**1521 Varnum Street, NW
Multi-Family Residential
Development**

Zoning Peer Review Report

June 9, 2015 (Updated)

Diagram No. 1: Partial First Floor Plan identifying infringement of adjoining property at 1519 Varum Street, NW

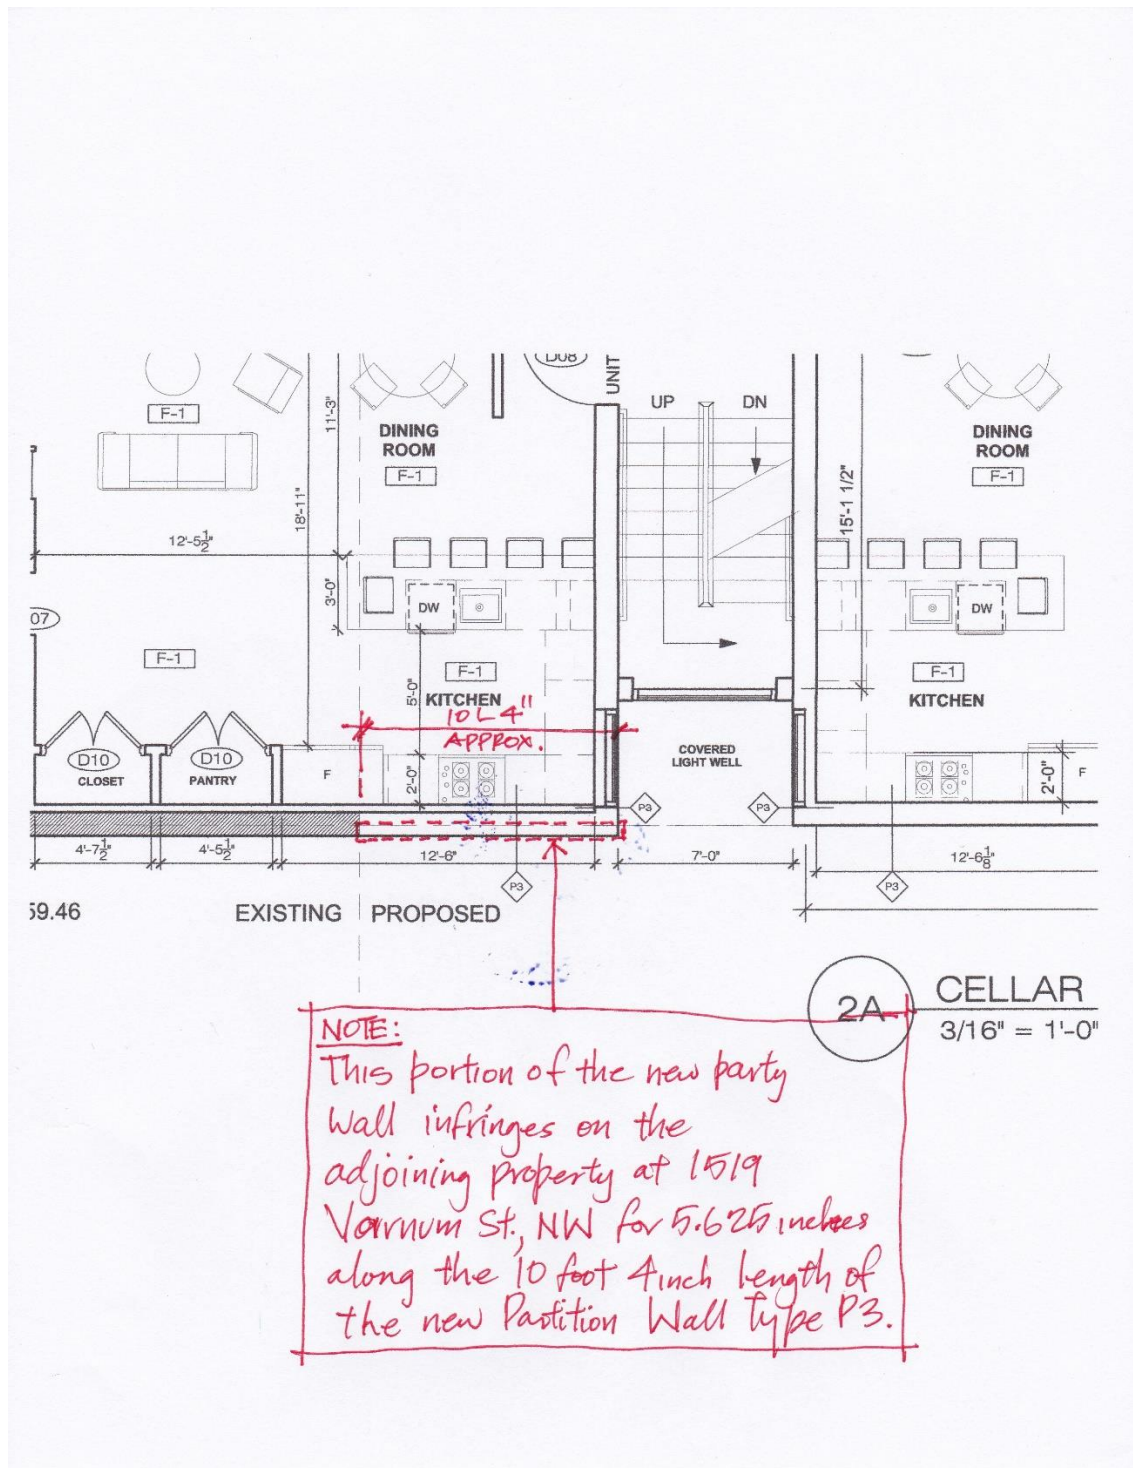
PEER REVIEW NOTE #2: The proposed development footprint is non-complaint because it goes over the eastern lot boundary line, as observed when coordinating the updated DC Surveyor Plat with the floor plan drawings on Sheets A201 and A202. The new Partition Wall P3 that extends the existing eastern party wall further north, infringes on the adjoining property at 1519 Varum Street, NW for 5.625 inches along the 10 feet 4 inch length of the new Partition Wall P3 wall type.
